Preliminary Drainage Report

Waterview East Commercial El Paso County, Colorado

PCD Filing No.: SP-22-009

Prepared: August 10, 2023

DETENTION BASIN STAGE-STORAGE TABLE BUILDER

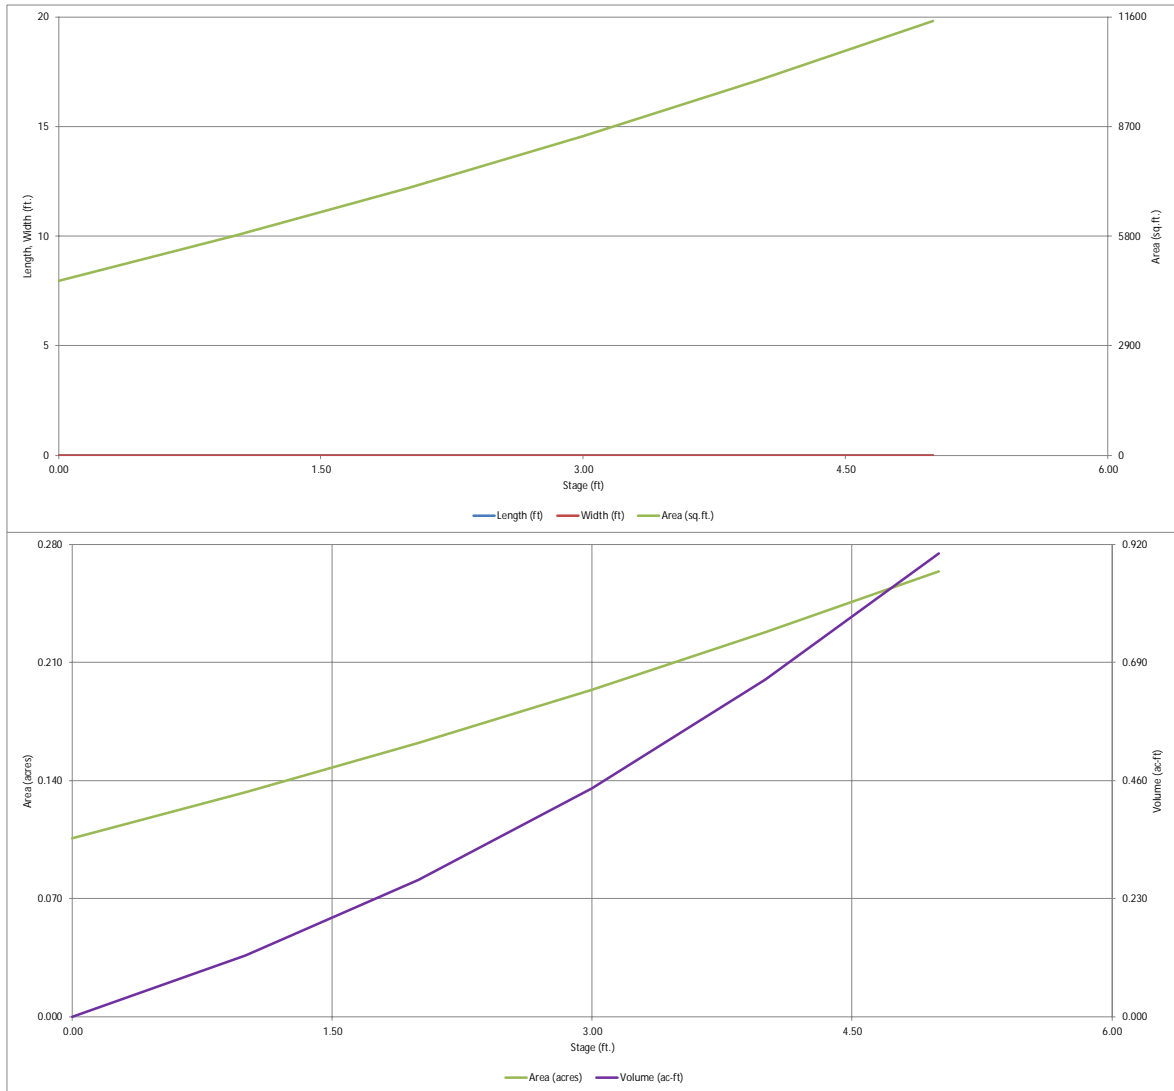
Revise to 1.34 as shown on the calc spreadsheet.

WATERVIEW EAST COMMERCIAL
CONSTRUCTION DOCUMENTS
EXISTING DRAINAGE MAP

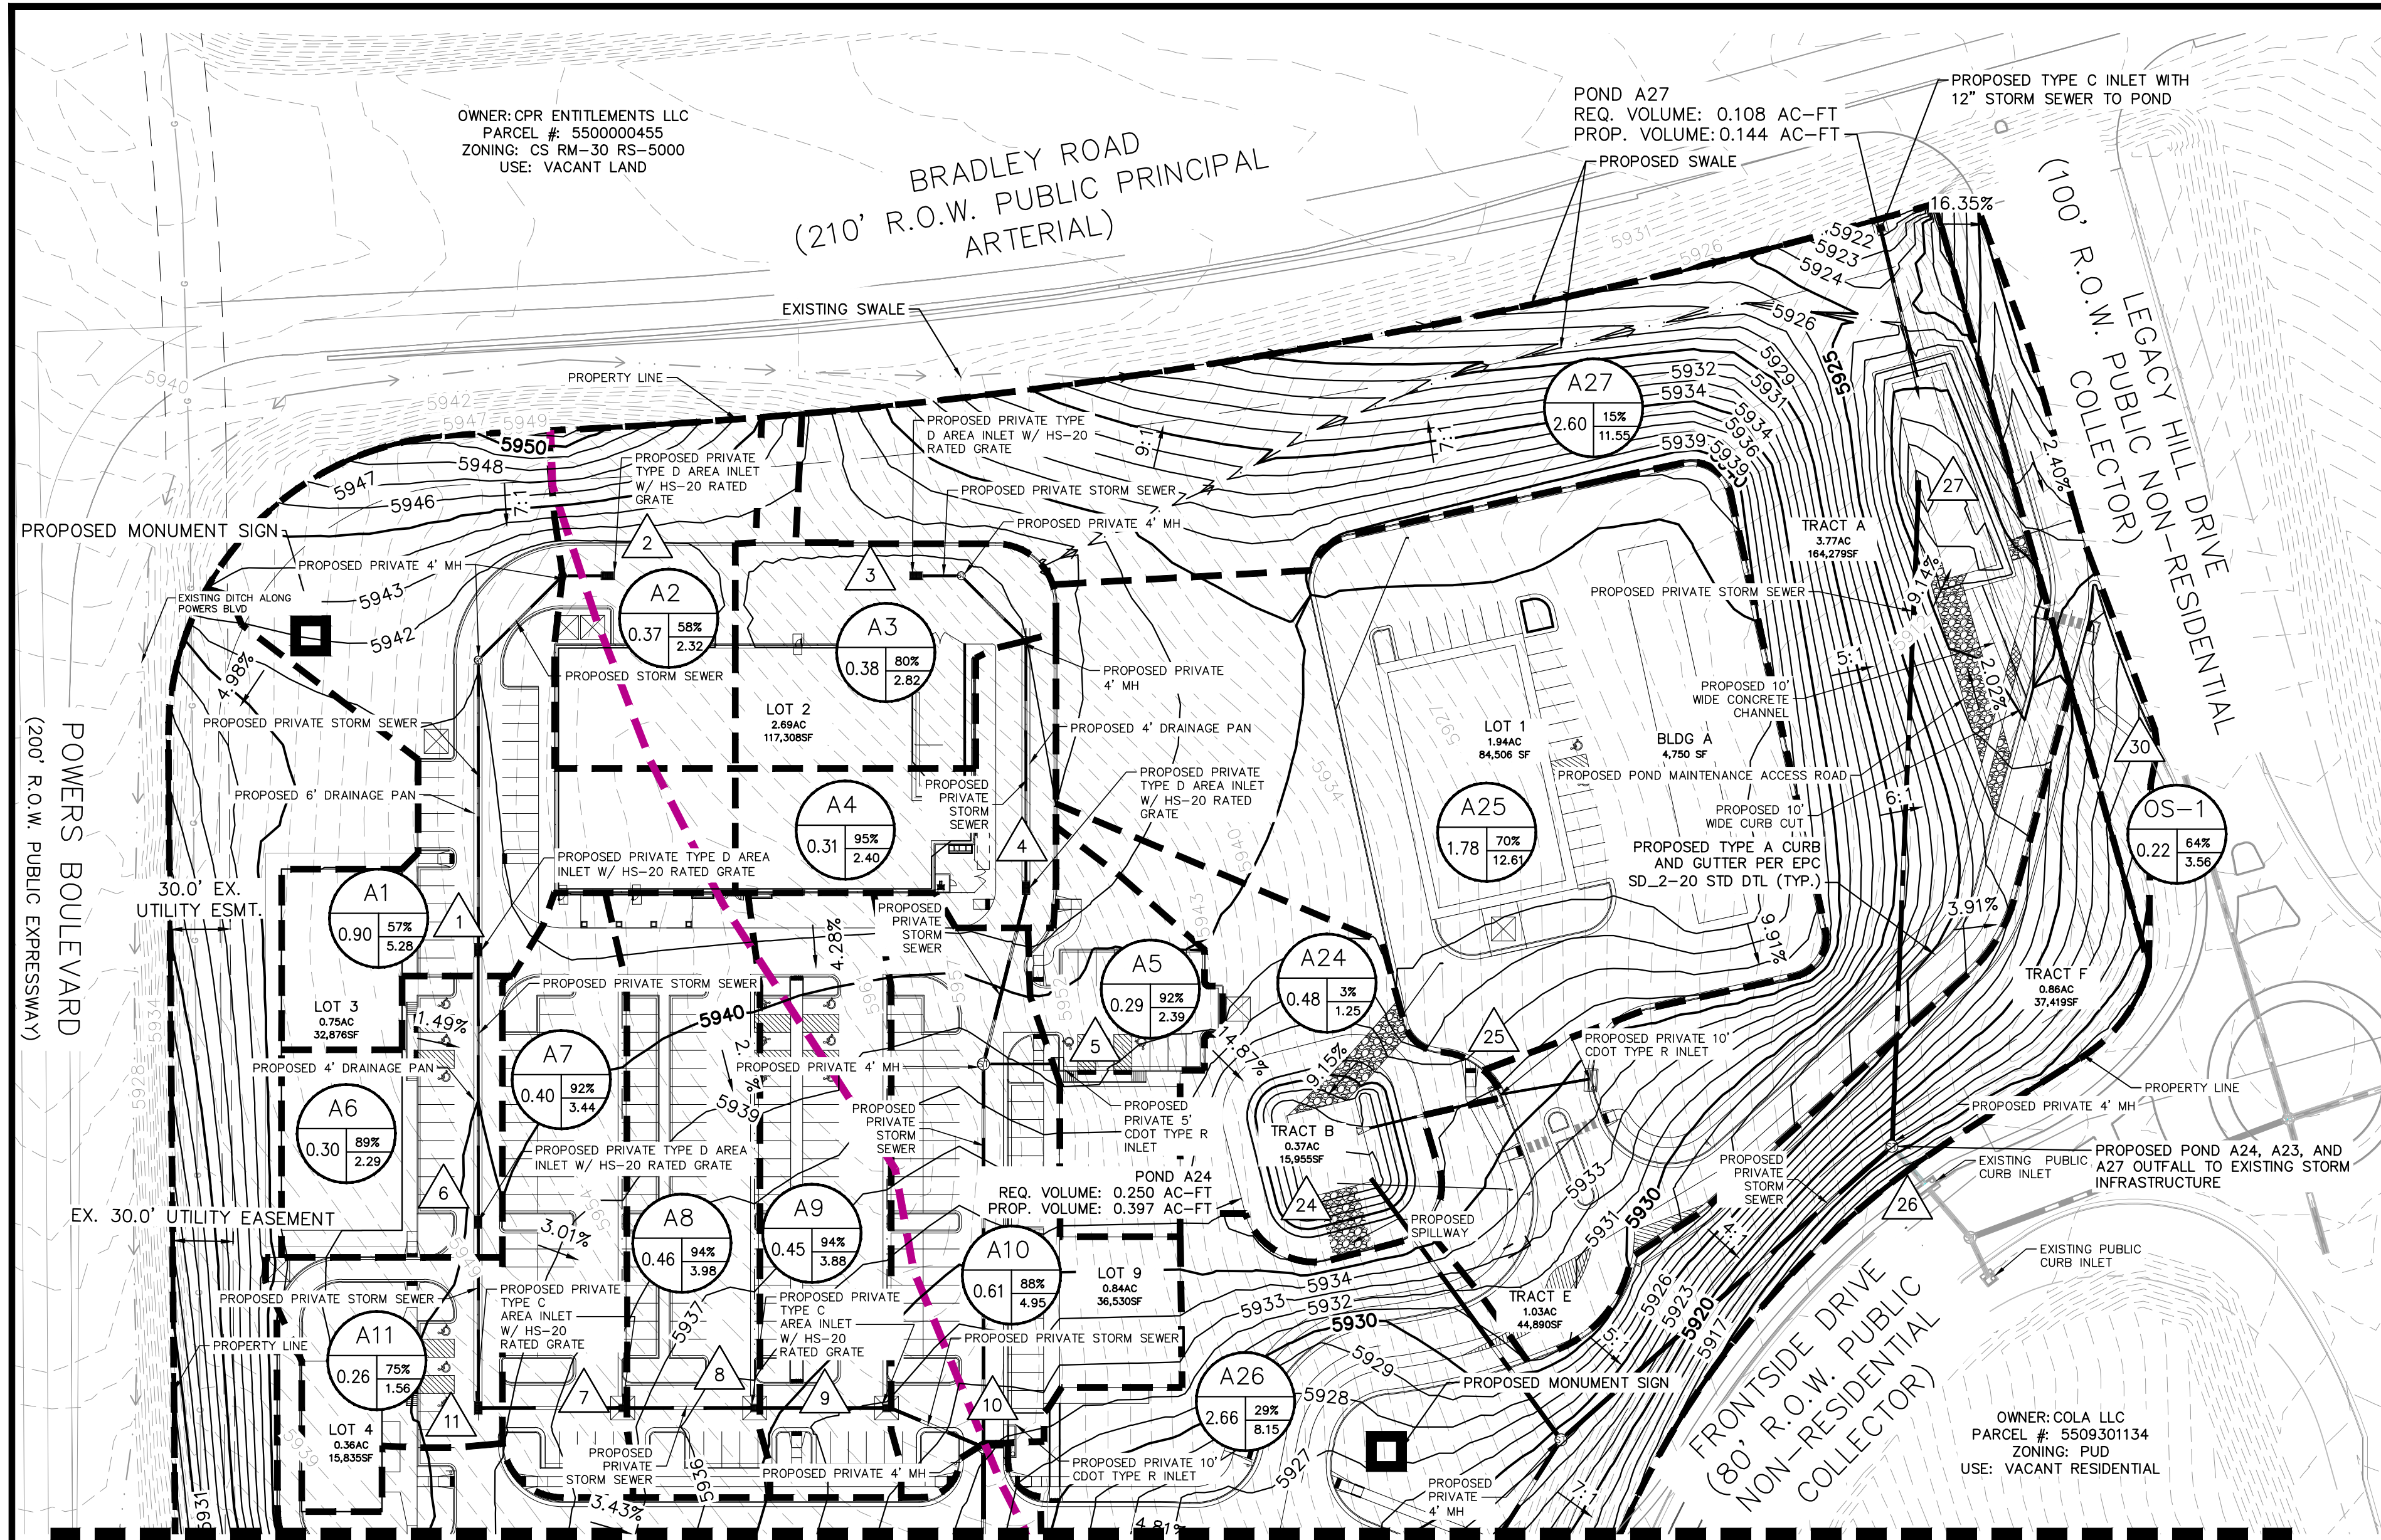
The proposed grading for basin A28 significantly alters the existing slopes from the existing condition. Per clarification with CDPHE, this would make these areas not applicable to the exclusion in ECM App I.7.1.B.7. However, since this basin is remaining pervious post-construction, you can call it an "SPA" and show that they provide their own WQ treatment via MHFD's Runoff Reduction tab in the UD-BMP spreadsheet. And then revise the WQ treatment statements in the basin summary descriptions on the drainage report text page 15 and the PBMP summary table on this sheet.

What about OS-1? Add this to the text and PBMP summary table.
